Final Hearing Comments

Reconsideration of Sabina/B2Gold's "Back River Energy Centre" Project Proposal

TRANSPORT CANADA'S MANDATE
Δ³Γ⁴ϒ⁵⊂ℕ₁₂∖ bαCΓ∧⊂ℕ[▷]Δ³Γ⁴∩
Ingilgaaliḡiyit Kanatami Maliniaktait

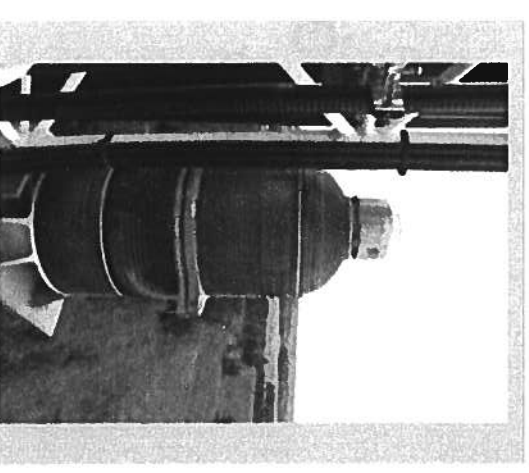
Prior to constructing the wind turbines, Sabina/B2Gold must submit an Aeronautical Assessment Form to ensure the turbines will be visible to aircraft.

To ensure the wind turbines are visible to aircraft, they must be lit by red flashing lights.
